ADDENDUM NO. 3

**South Fountains Restoration
Missouri State Capitol Building
Jefferson City, Missouri
PROJECT NO.: 02204-01**

JUNE 3, 2025

A FOUNTAIN SITE DRAINAGE PLAN VIEW
Scale: 3/16" = 1'-0"

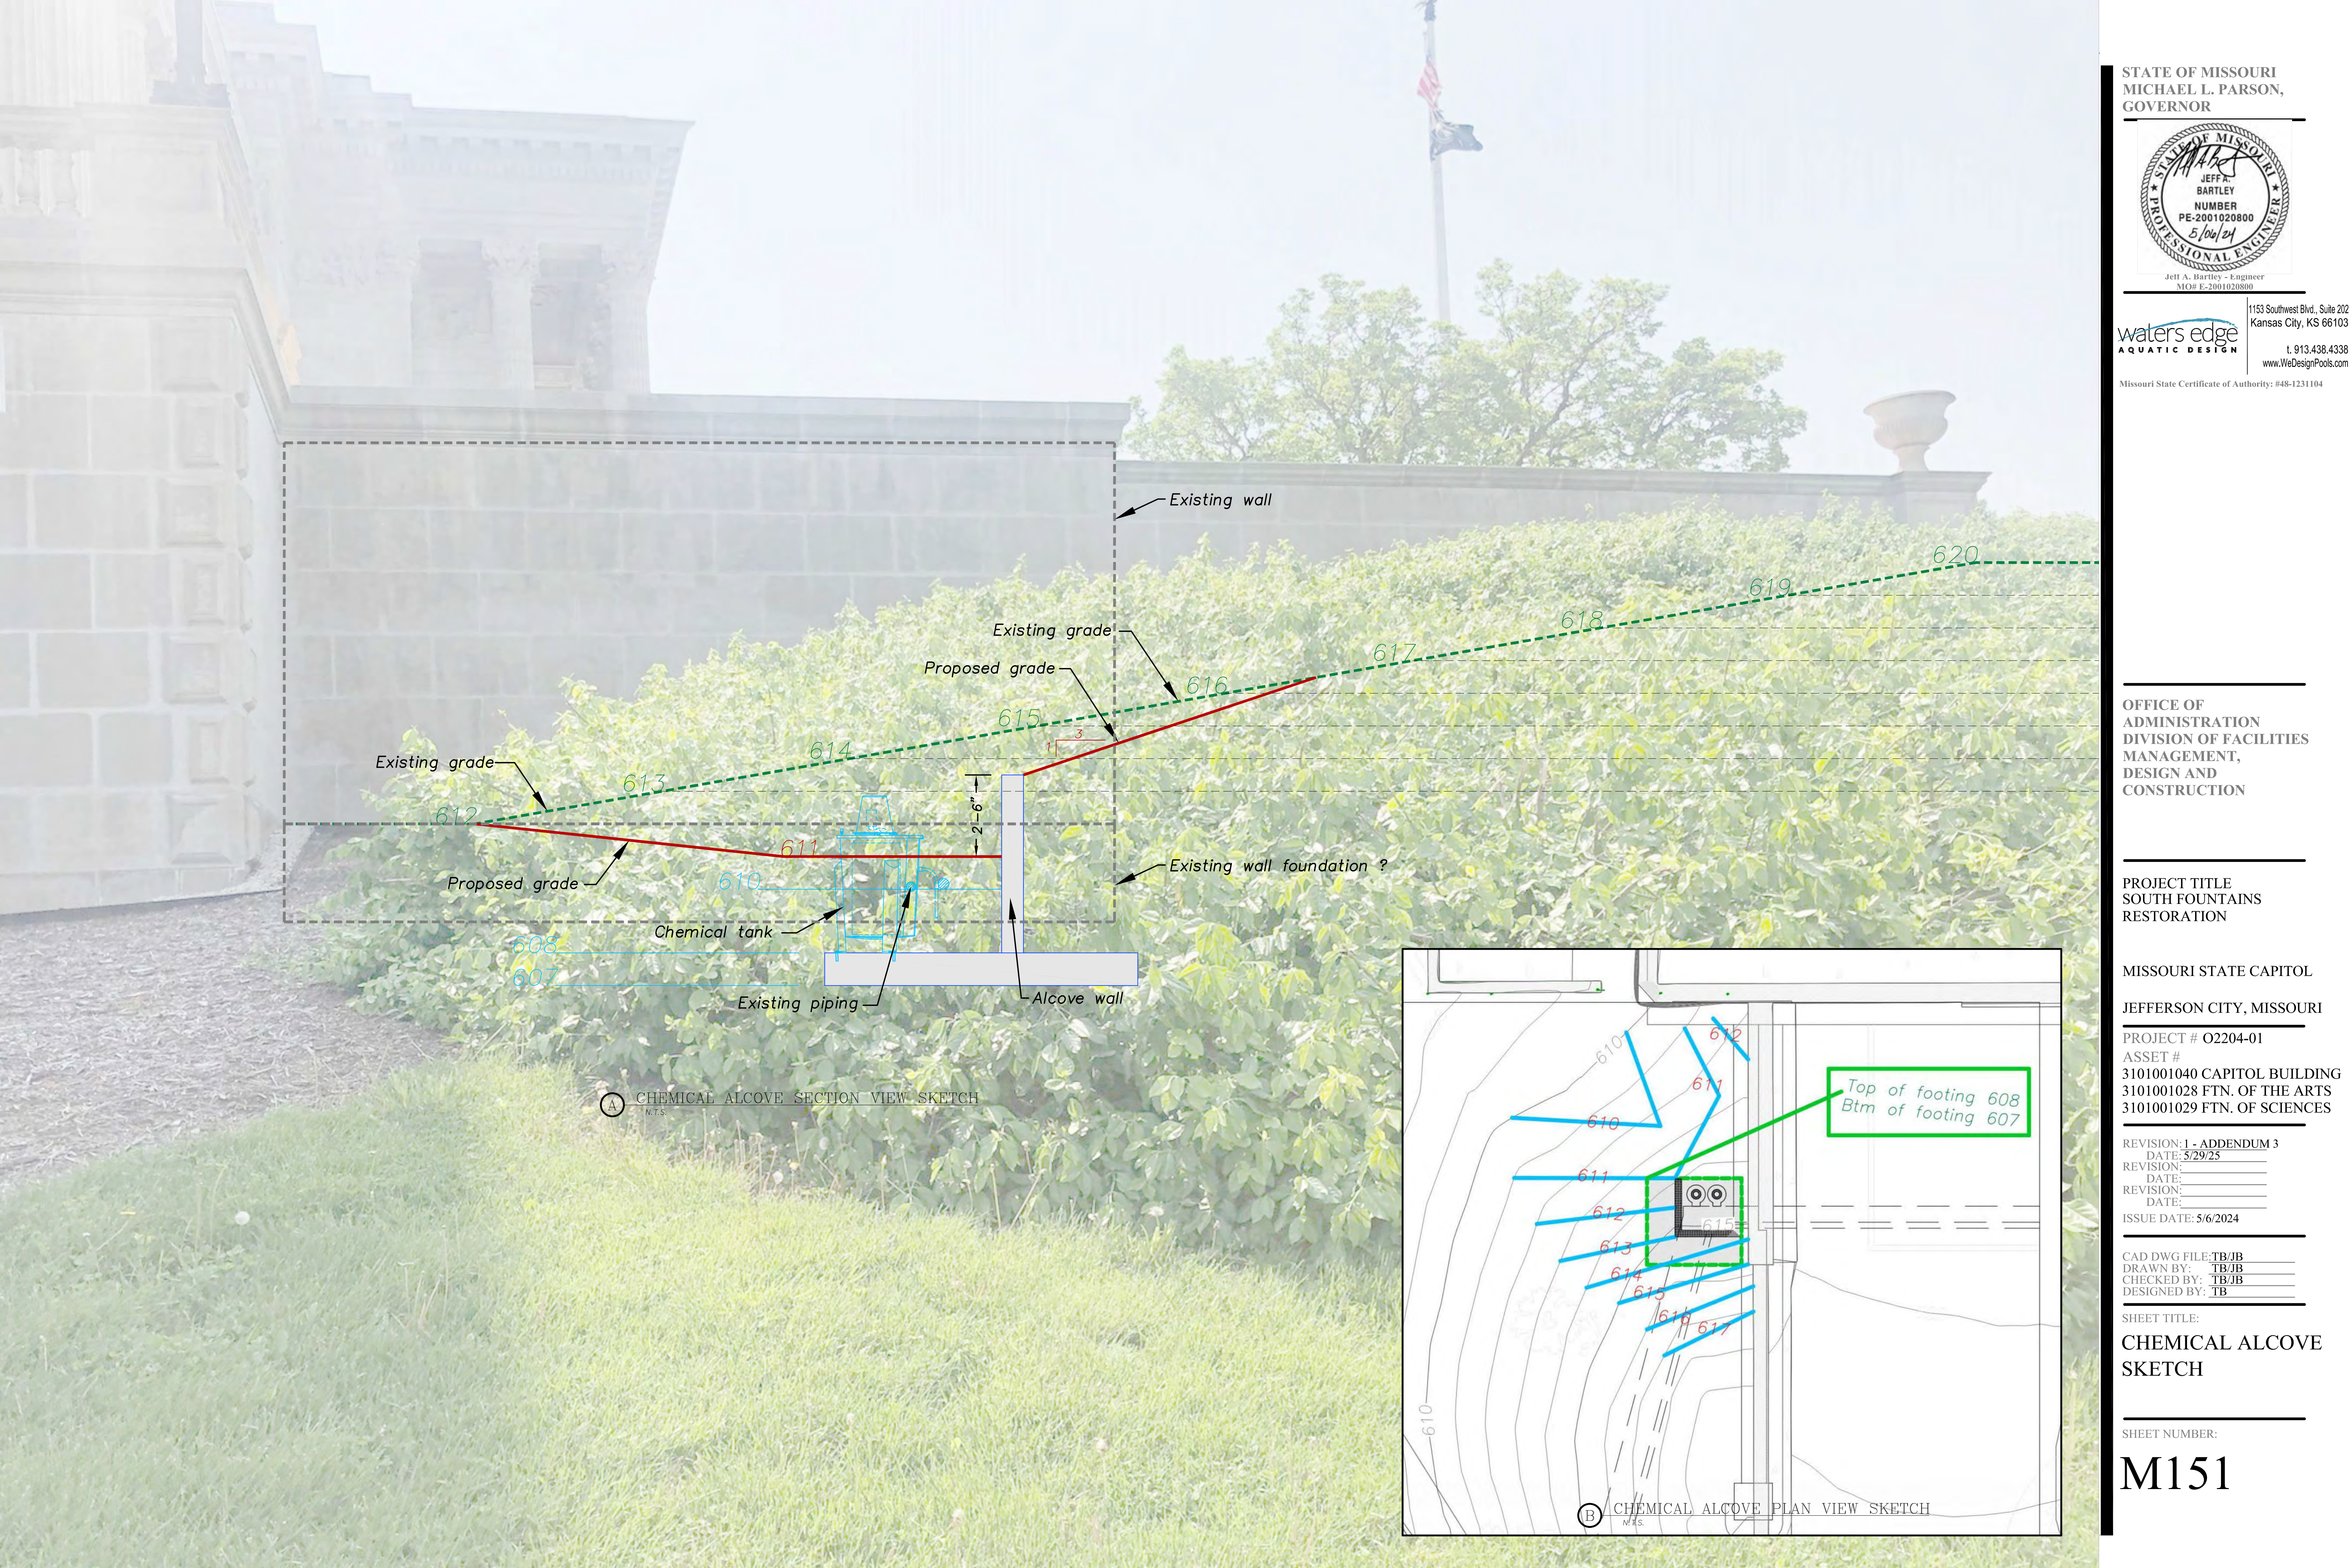
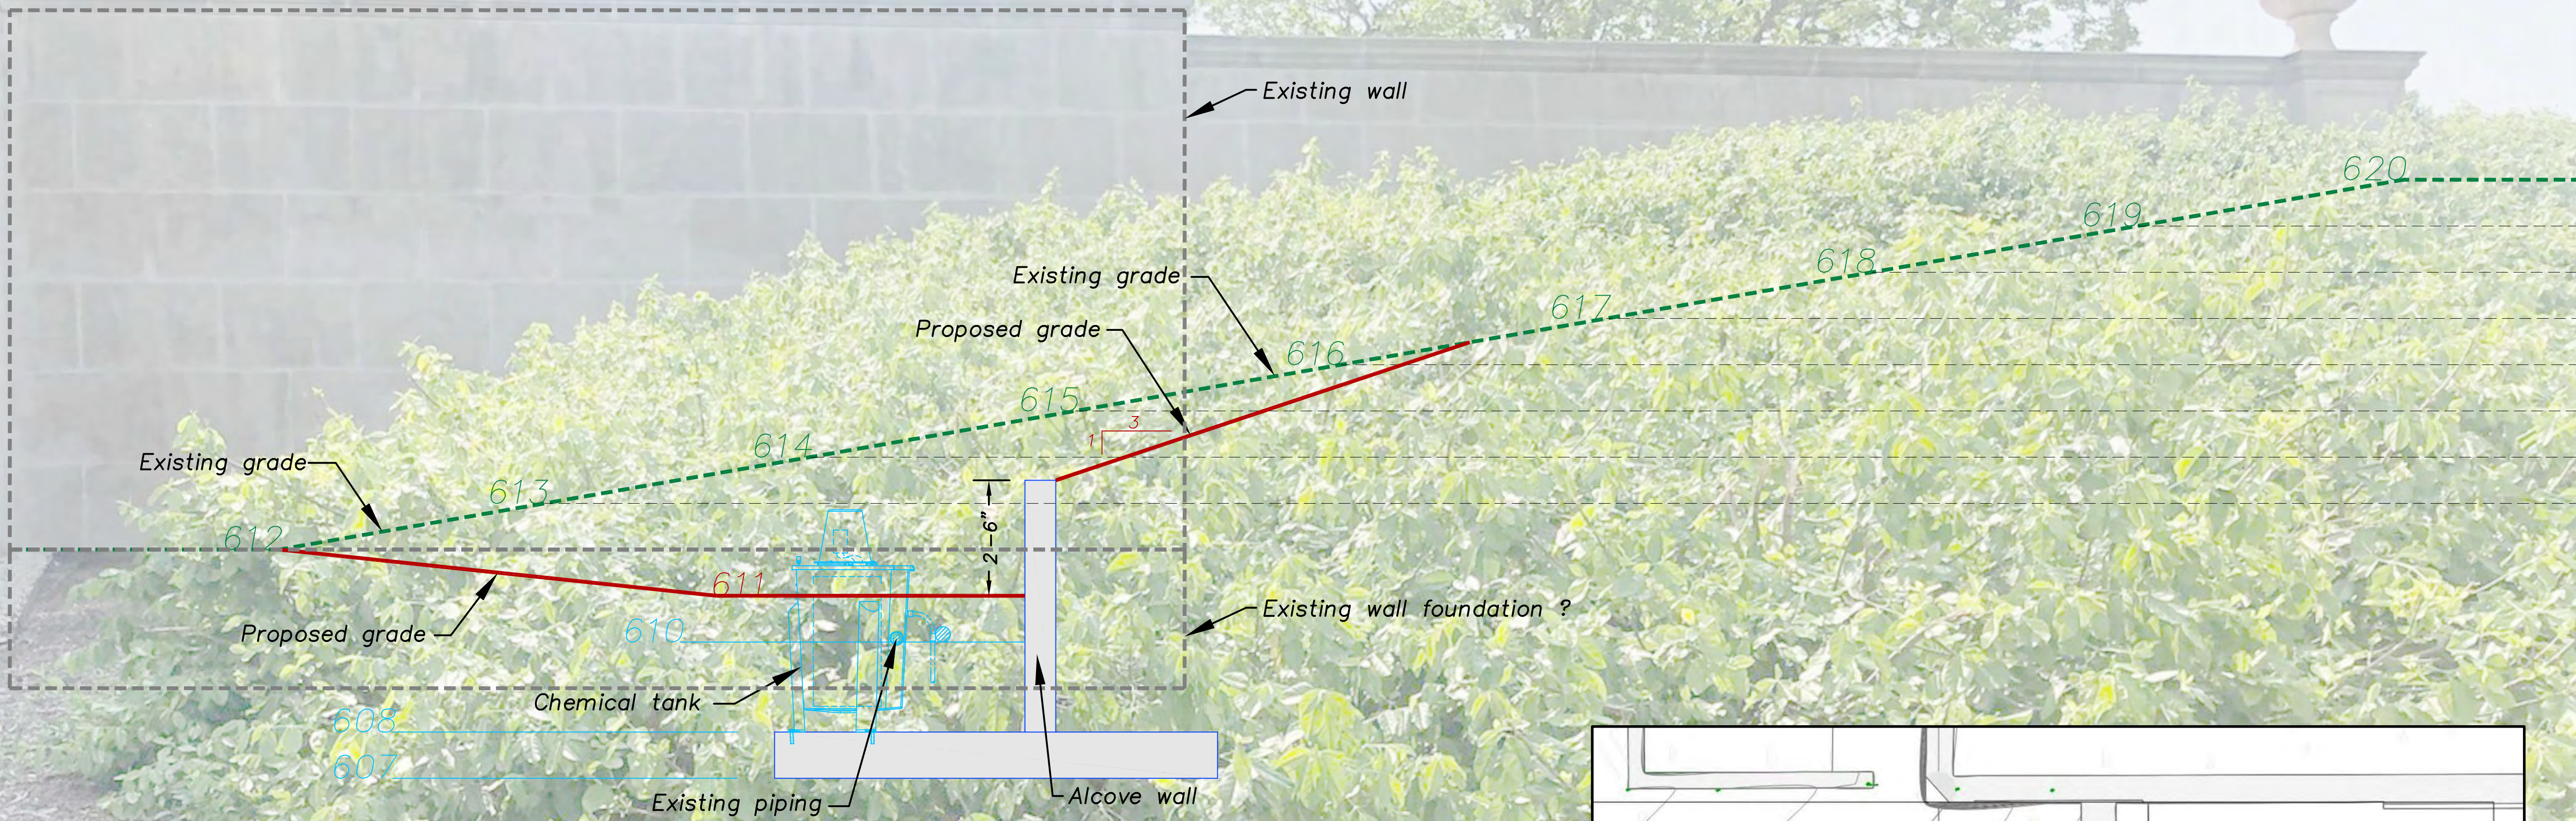
7. Sheet M102
 - a. REVISE note to indicate to contractor to route drain piping along existing curb inlet piping route
 - b. ADD note to indicate to contractor to core new drainpipe into existing curb inlet

(A) CHEMICAL ALCOVE SECTION VIEW SKETCH
N.T.S.

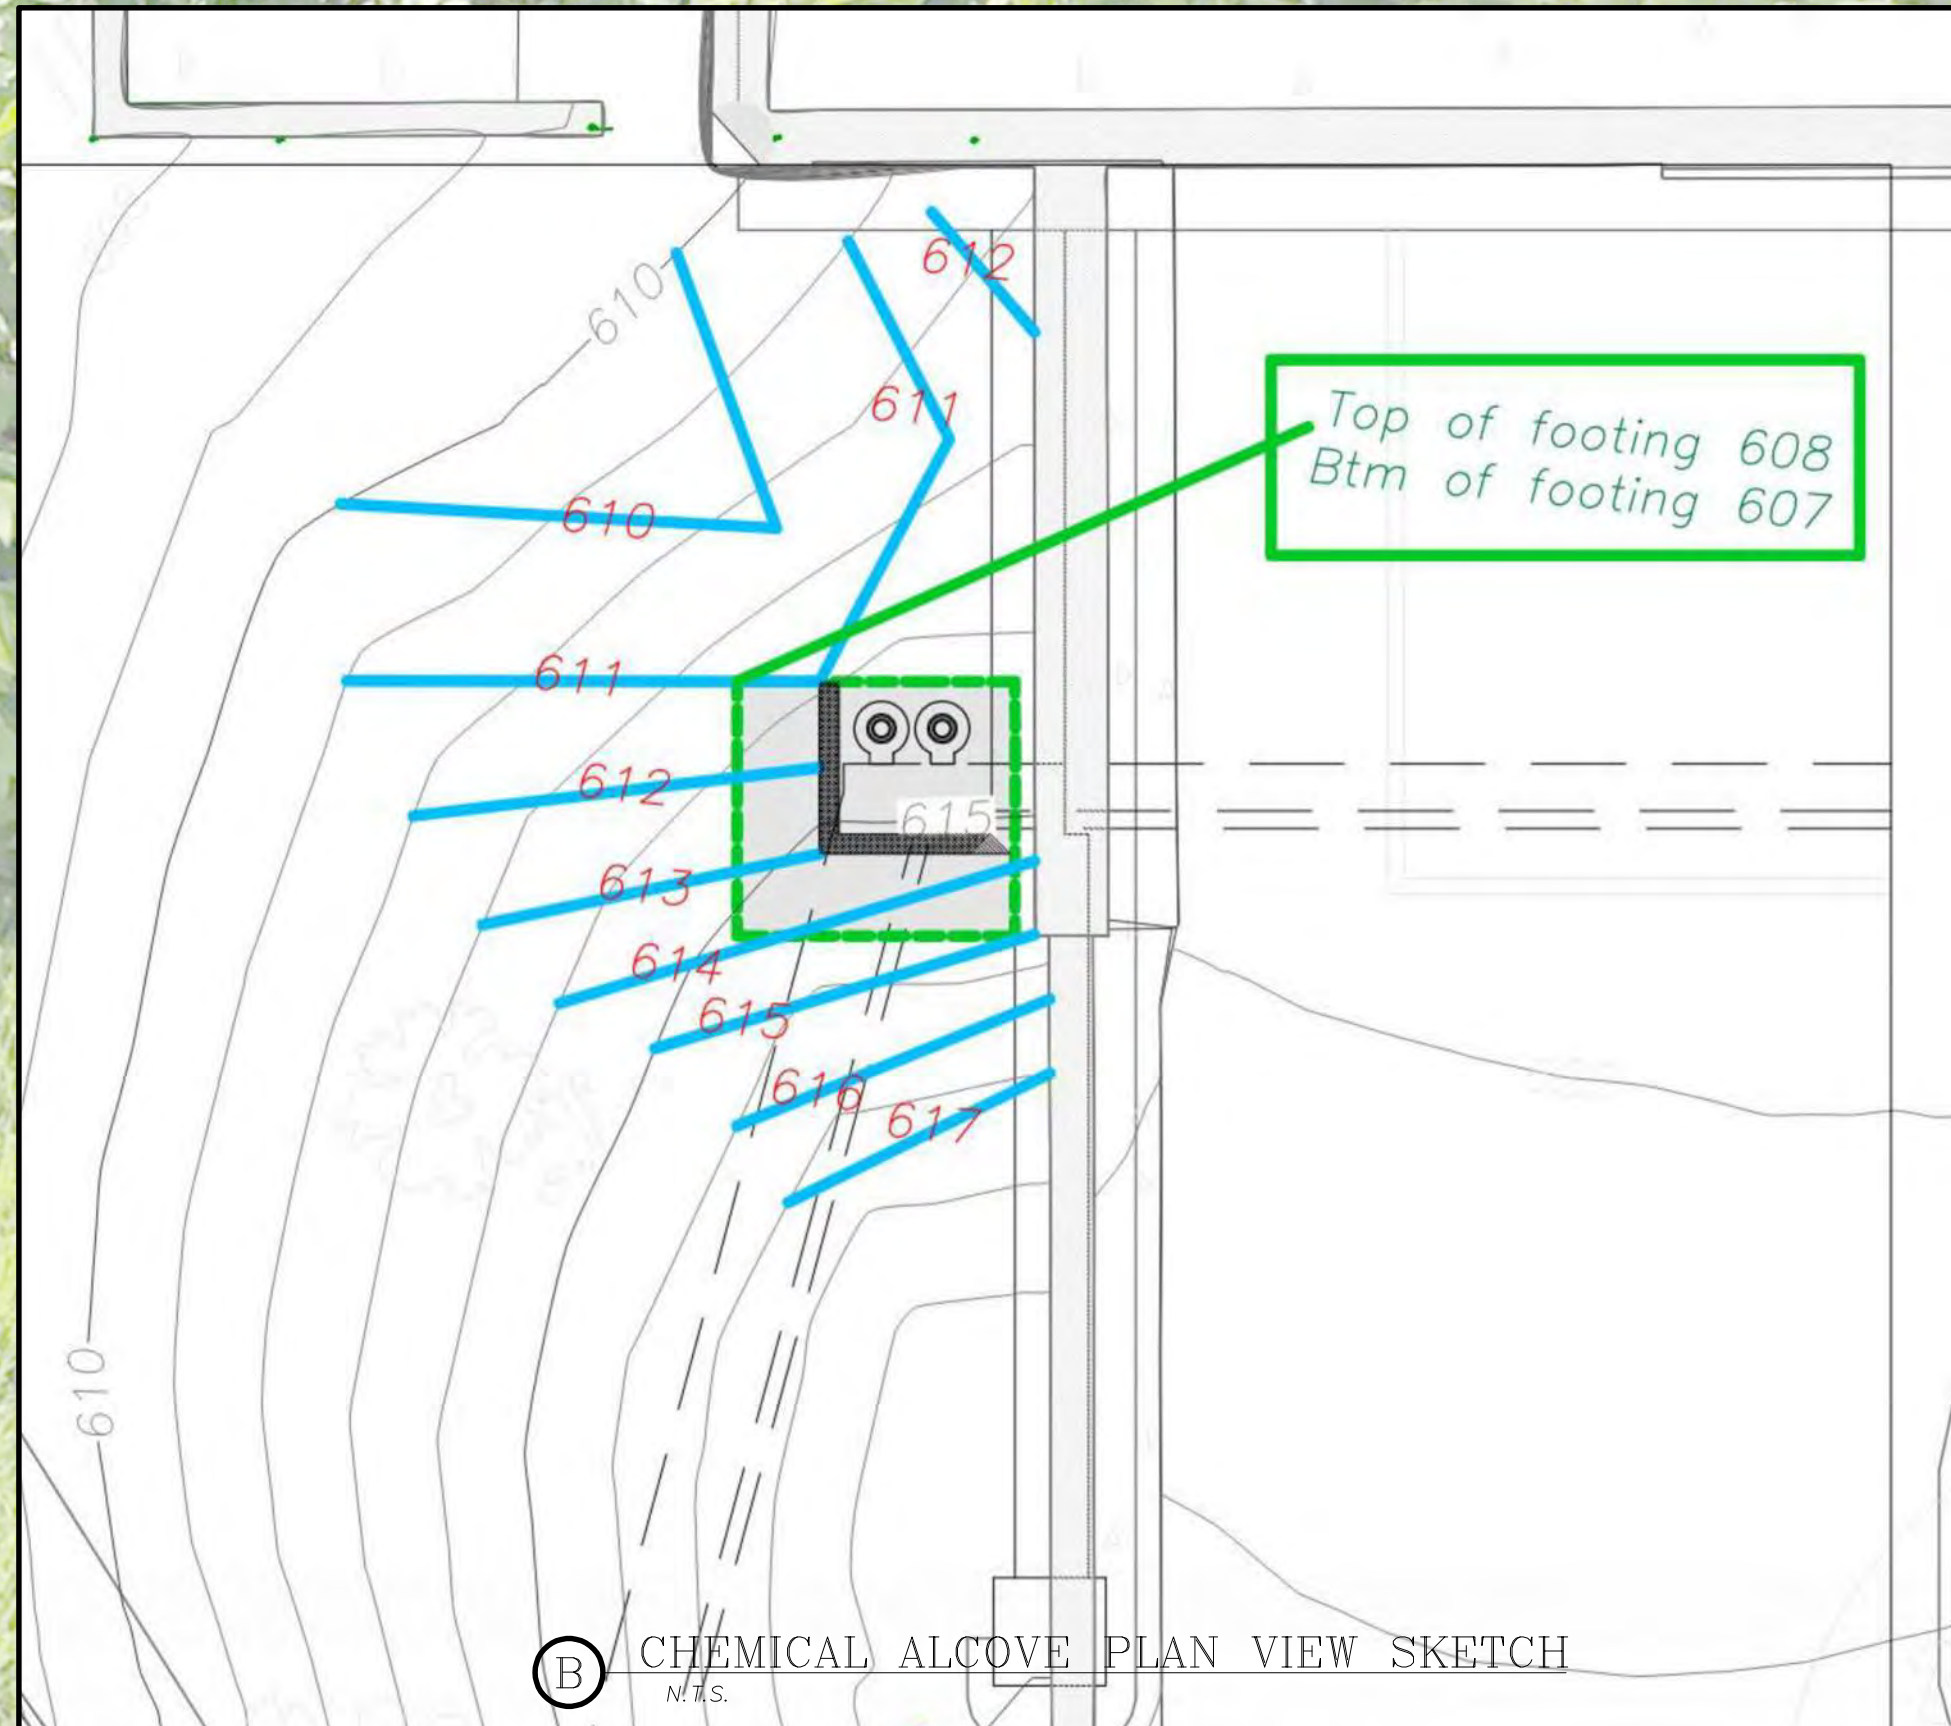
- b. Detail B -
 - ADD note indication to contractor to anchor the chemical tank to the retaining wall, anchor per manufacturer
9. ADD Sheet M151 Chemical Alcove Sketch

- Section cut sketch showing grading and footing depths (N.T.S.)
 - Plan view sketch showing grade changes around chemical alcove (N.T.S.)
